Proposed Updated Final Safety Analysis Report Tables and Figures
(Mark-Ups; for Information Only)
(164 pages follow)

FINAL PLANT LAYOUT, PLAN C ABOVE
ELEVS. 620'-6", 623'-6" AND
624'-6", PLANT COMPLEX
FIGURE 1.2-5
(DWG. E-013-0005-00000)

FINAL PLANT LAYOUT,
PLOT PLAN RELEASE POINT DESIGNATION
FIGURE 1.2-18
(DWG. D-036-0011-00000)

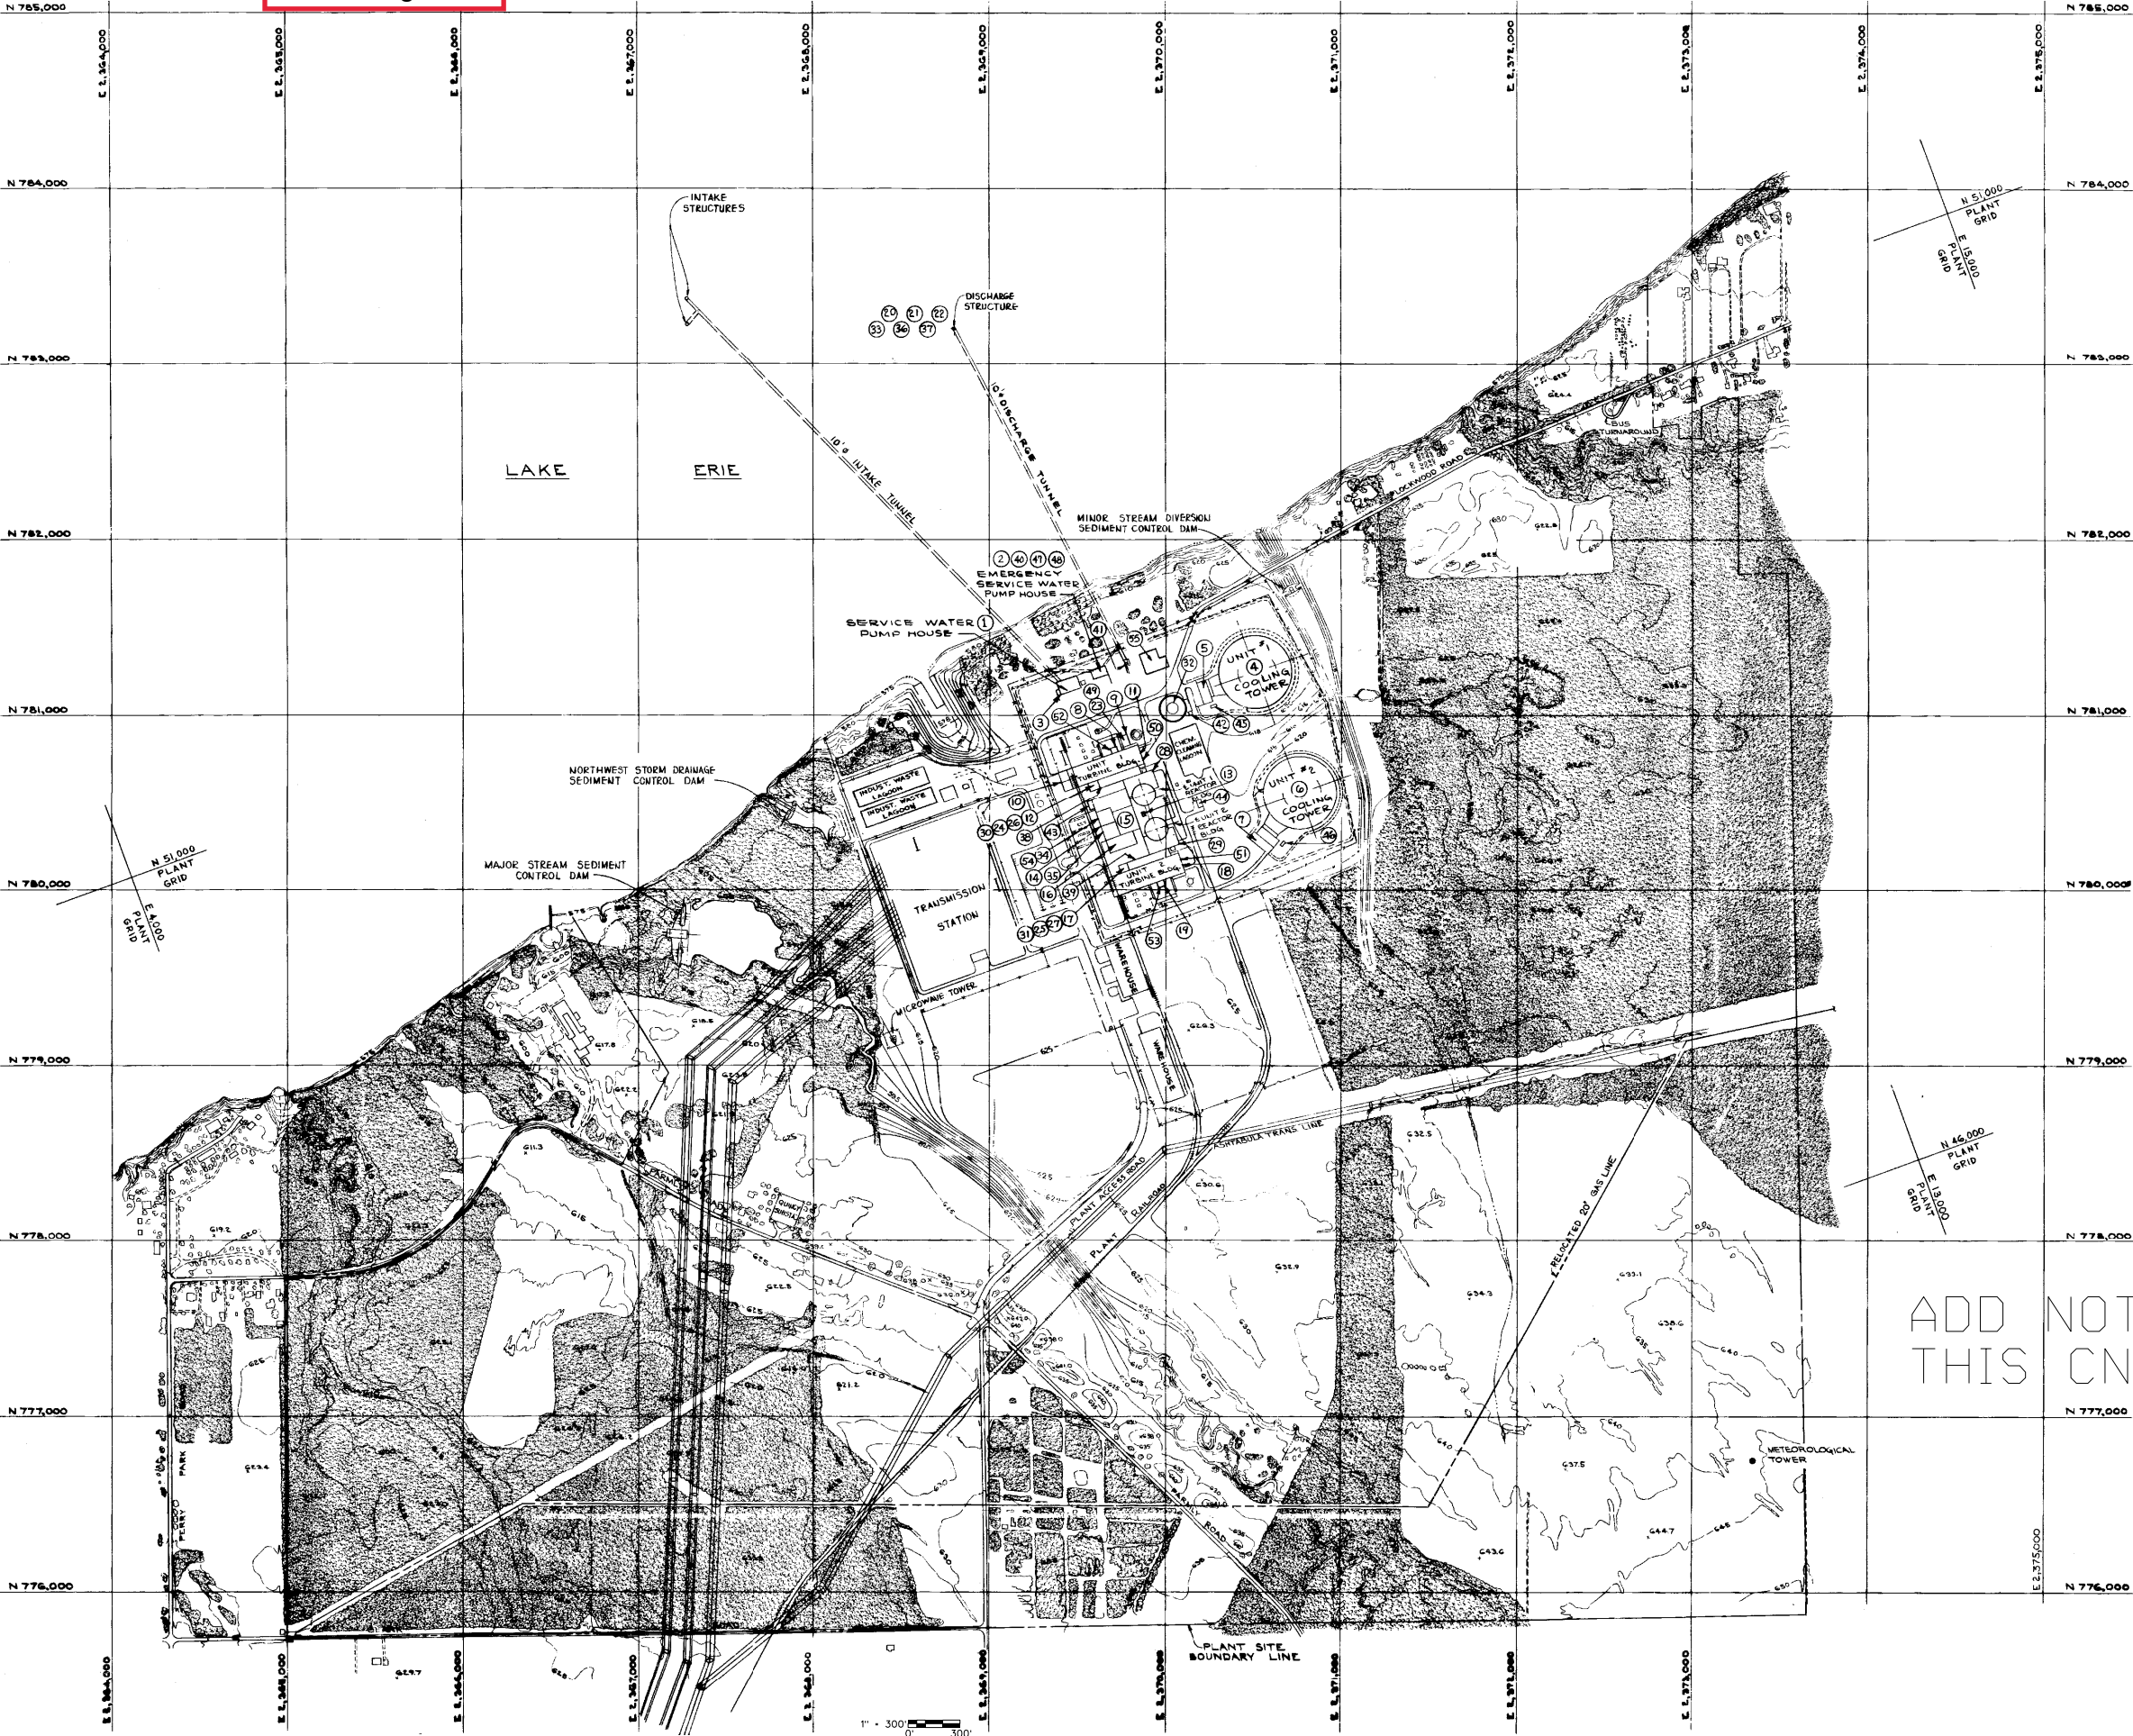
NOTES: 1. COORDINATES SHOWN ON THIS DRAWING ARE BASED ON THE OHIO STATE COORDINATE SYSTEM.
2. REACTOR COORDINATES:
OHIO GRID PLANT GRID
UNIT 1 N780,345 E2,369,875 N48,486 E9,570
UNIT 2 N780,346,725 E2,369,847,186 N48,255 E9,570
3. ALL BACKGROUND CONTOURS SUPPLIED BY AERIAL SURVEYS, INC.
* ABANDONED UNIT 2 RELEASE POINTS, NO SOURCE.
4. THIS USAR FIGURE CONTAINS HISTORICAL TOPOGRAPHICAL INFORMATION FOR REFERENCE ONLY AND WILL NOT BE UPDATED.

Figure 2.1-3

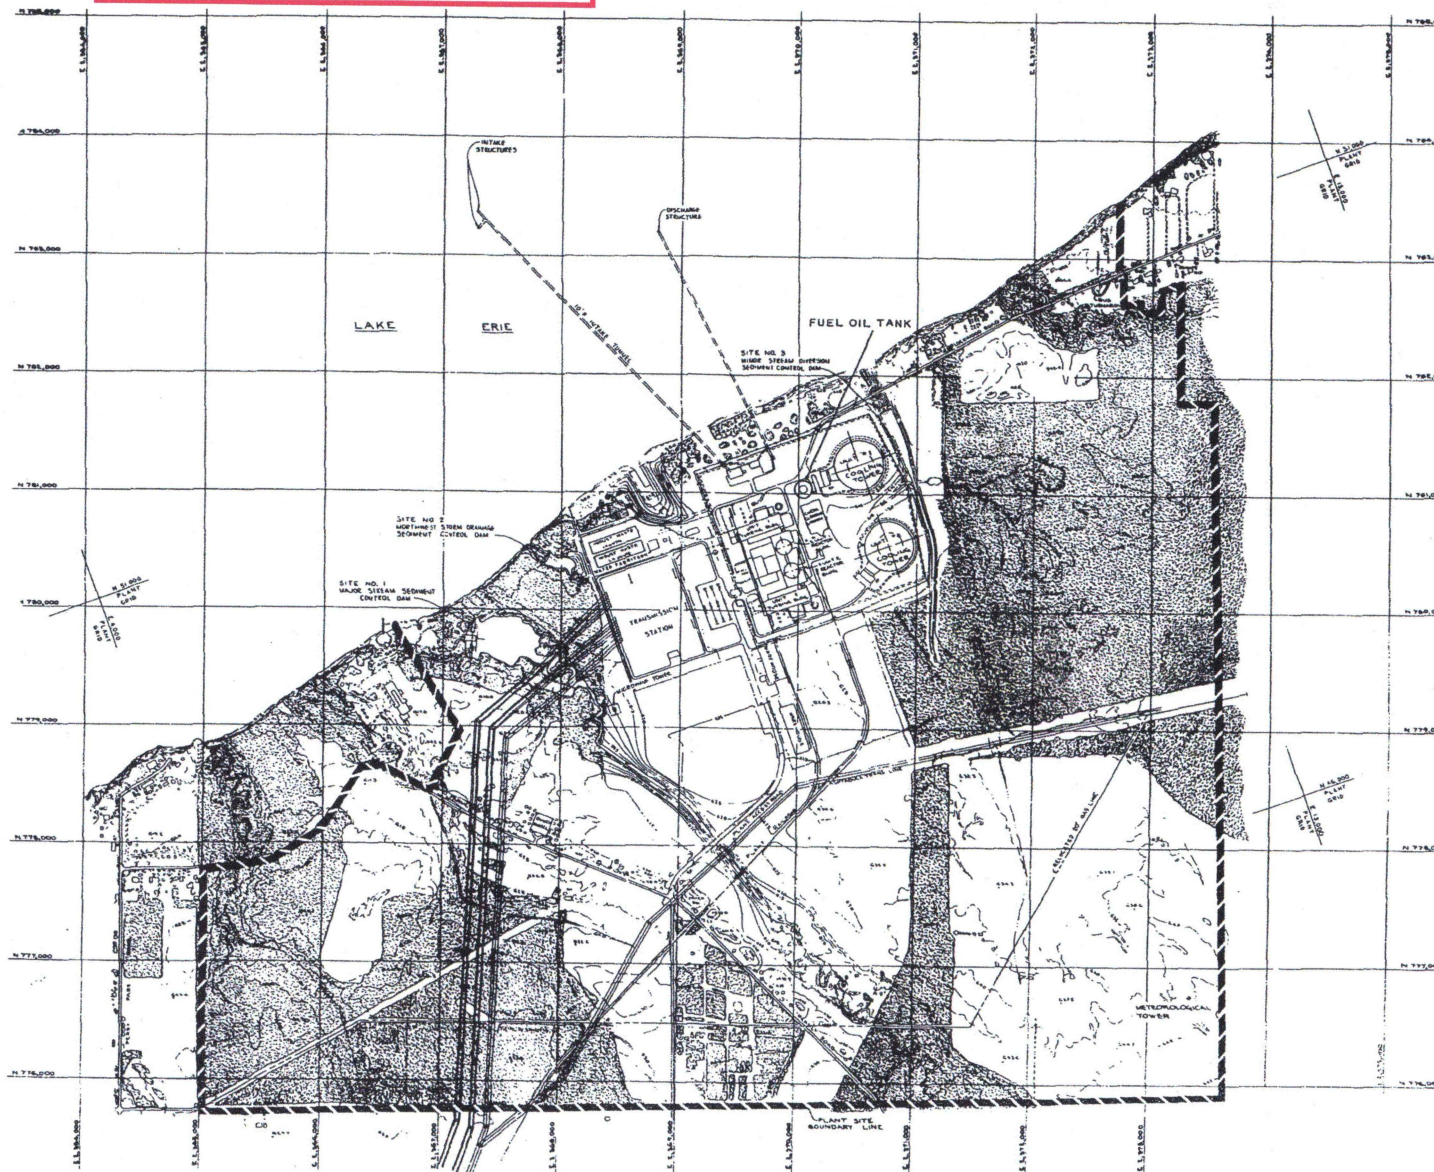
ADD NOTE
THIS CN

THIS USAR FIGURE CONTAINS HISTORICAL
TOPOGRAPHICAL INFORMATION FOR REFERENCE
ONLY AND WILL NOT BE UPDATED. FOR RECENT
TOPOGRAPHIC INFORMATION SEE FIGURES 2.4-83
AND 2.4-84.

NATURAL GAS PIPELINES WITHIN THE IMMEDIATE ENVIRONS OF THE PLANT
FIGURE 2.2-3

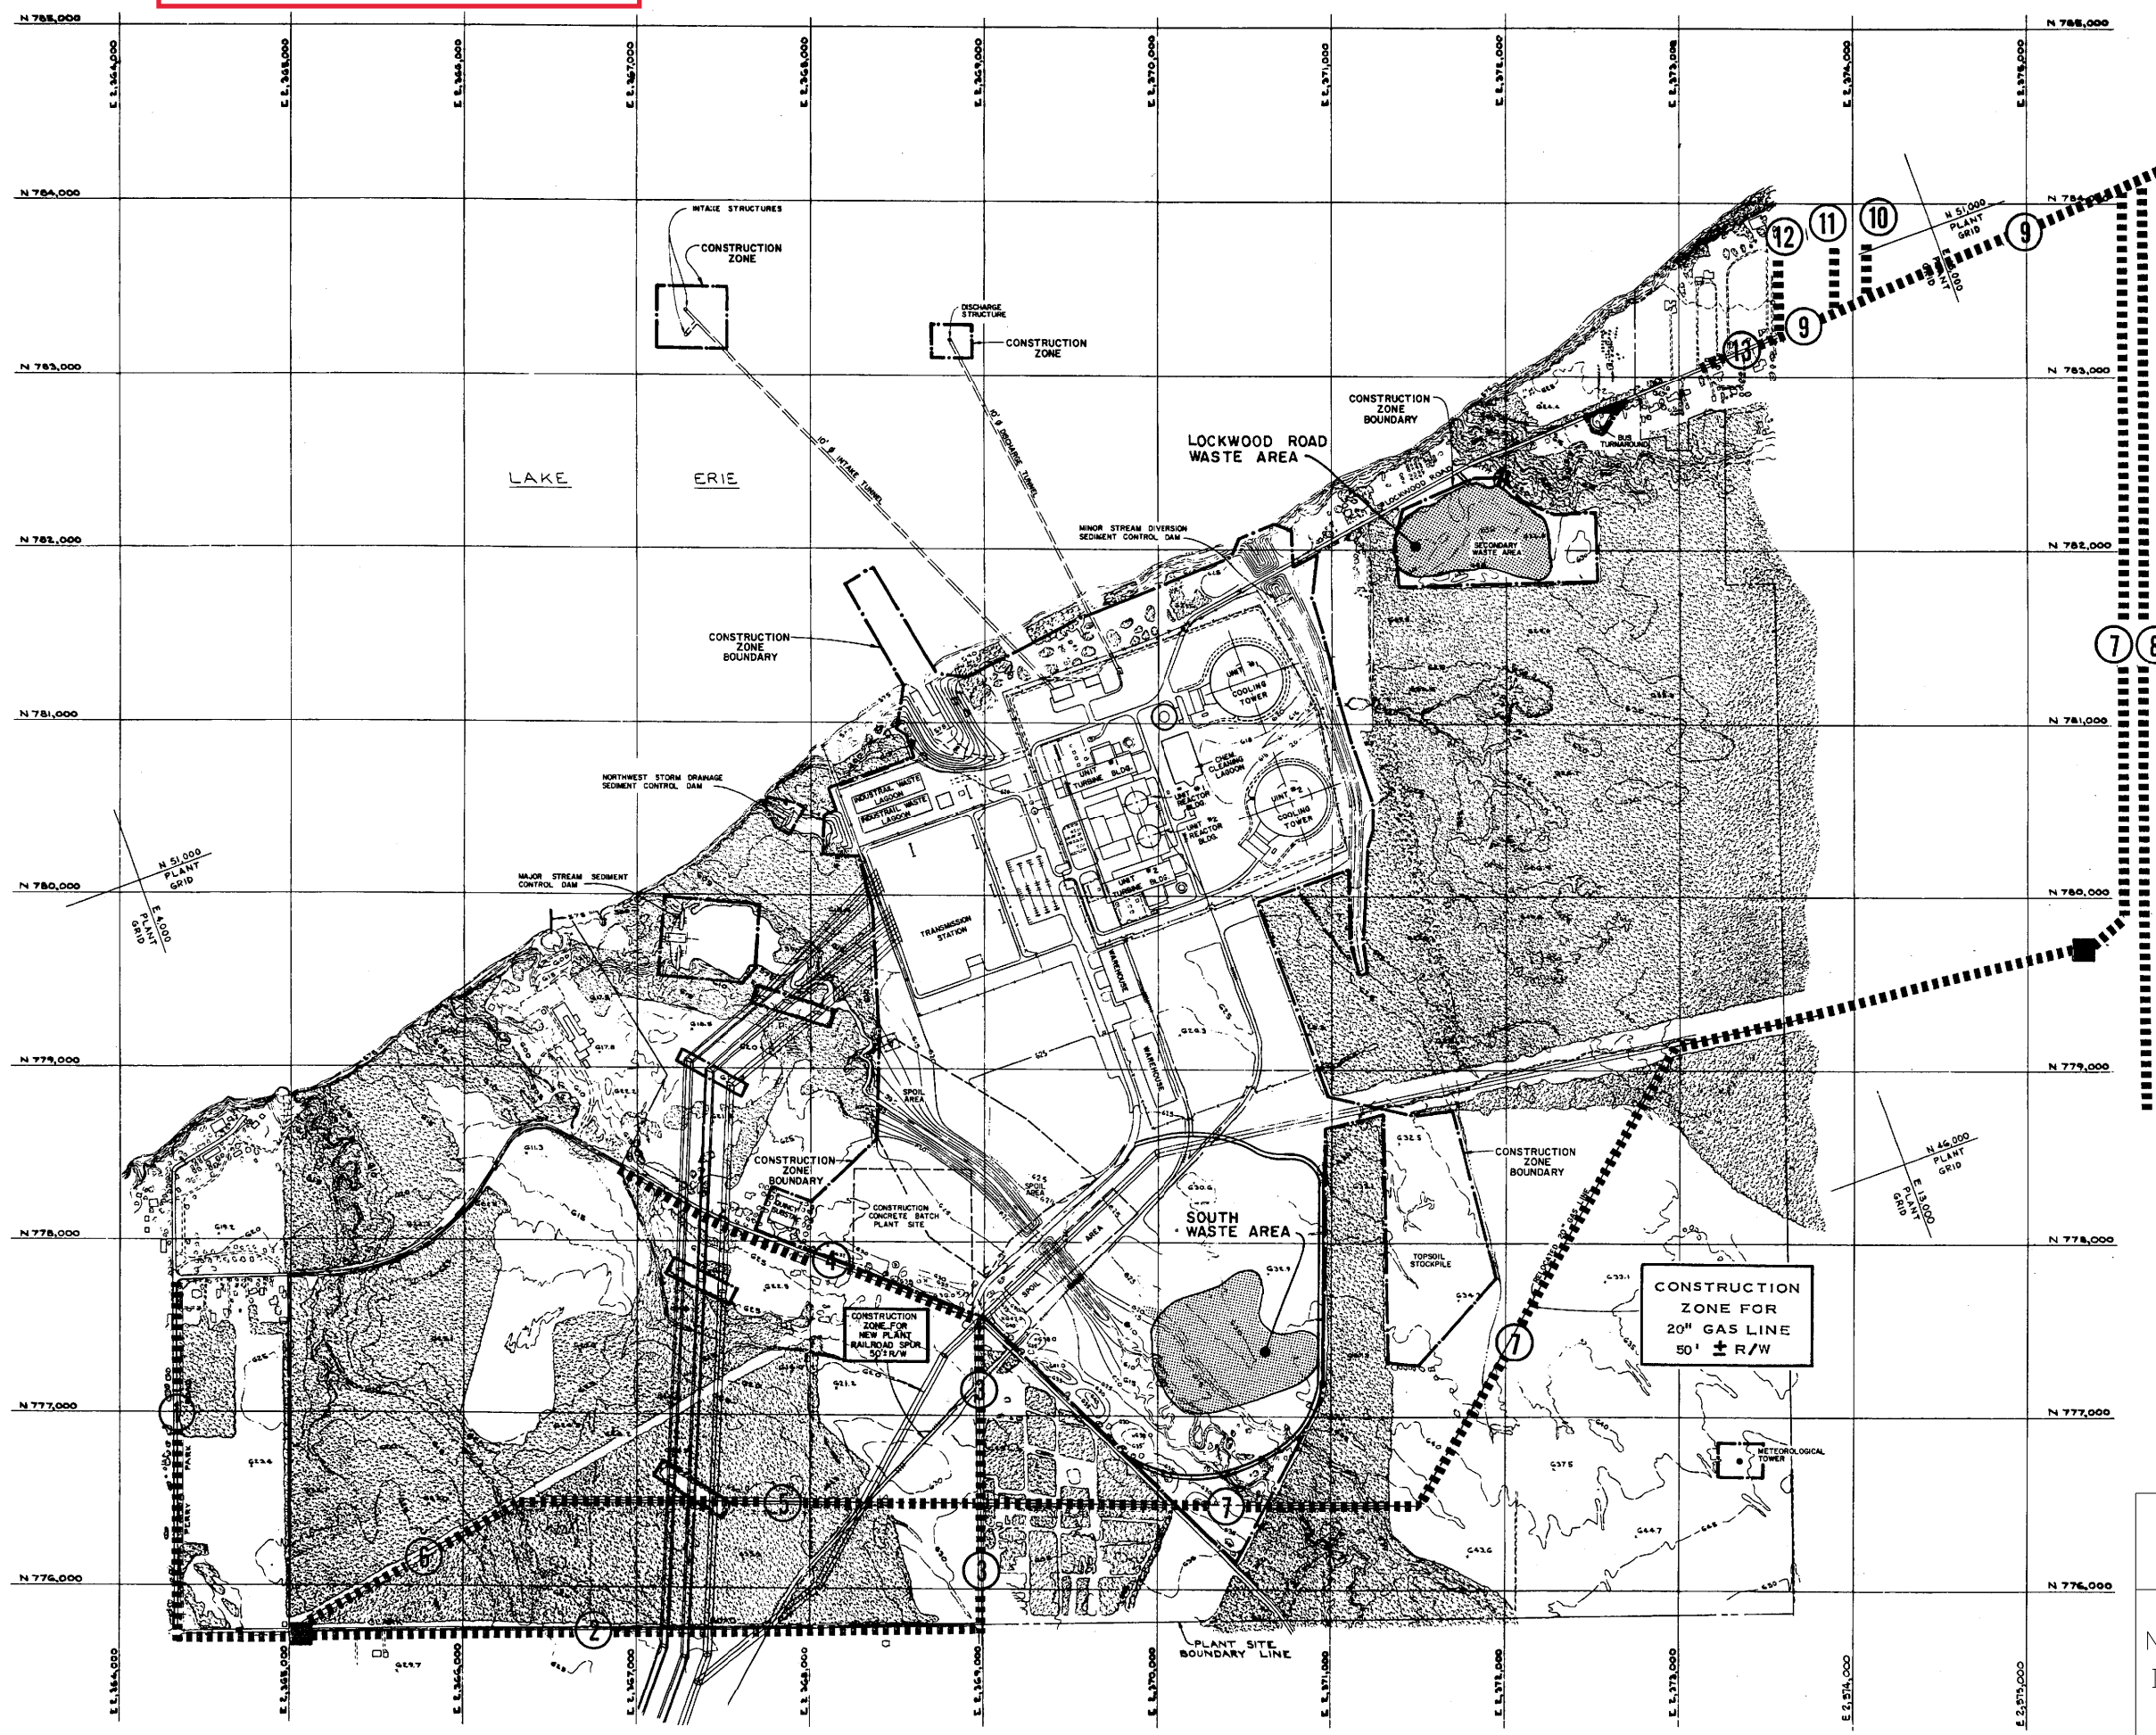
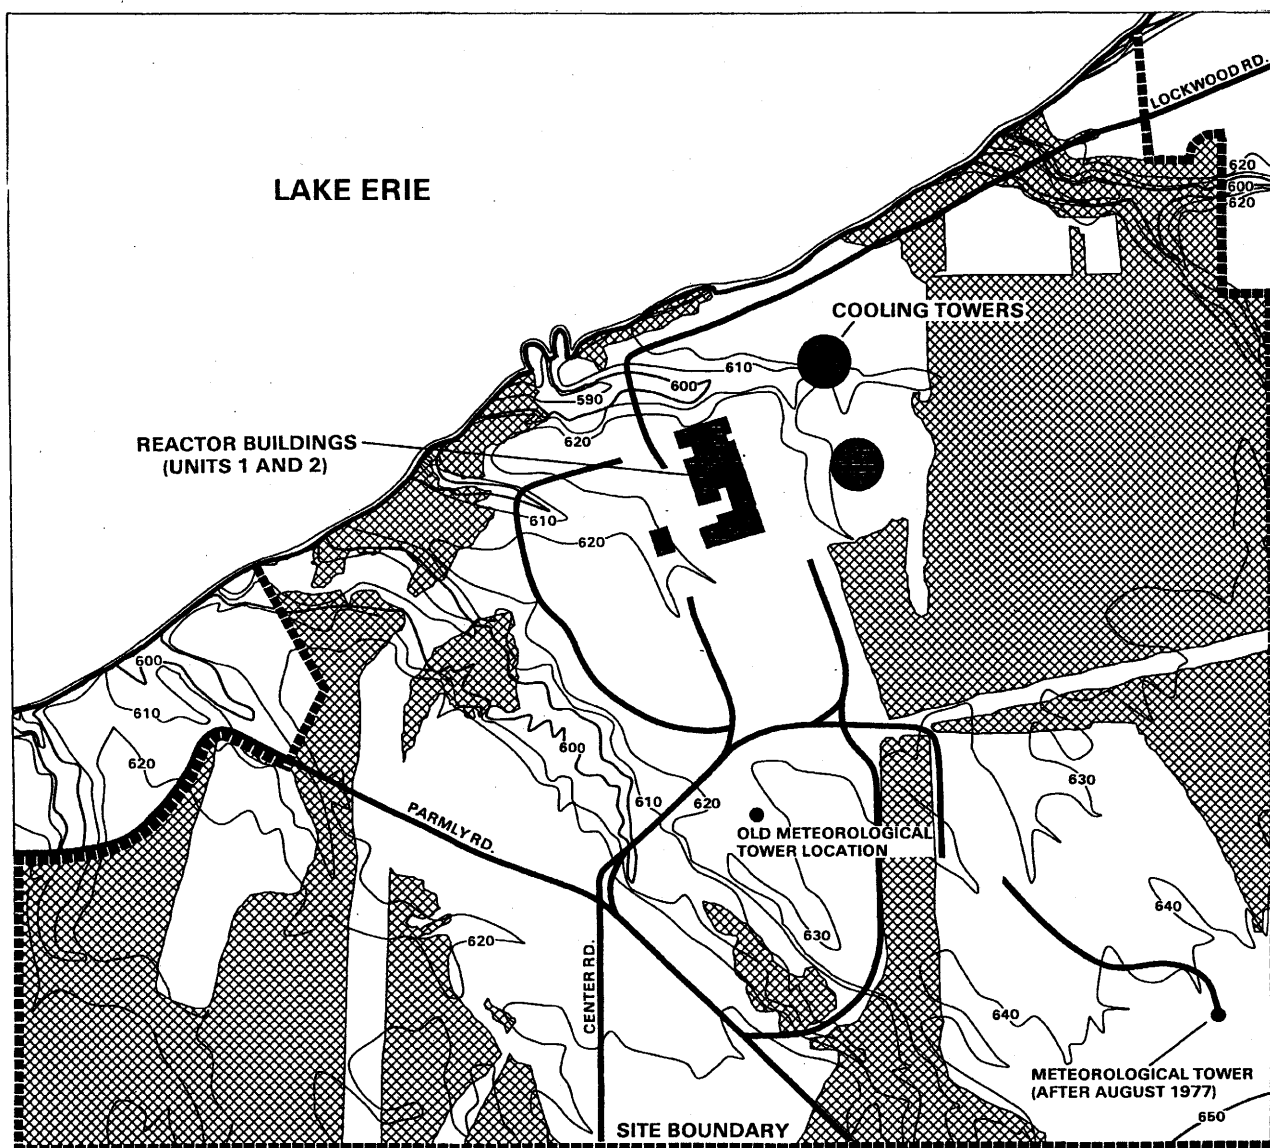
ADD NOTE THIS CN

3. THIS USAR FIGURE CONTAINS HISTORICAL TOPOGRAPHICAL INFORMATION FOR REFERENCE ONLY AND WILL NOT BE UPDATED.
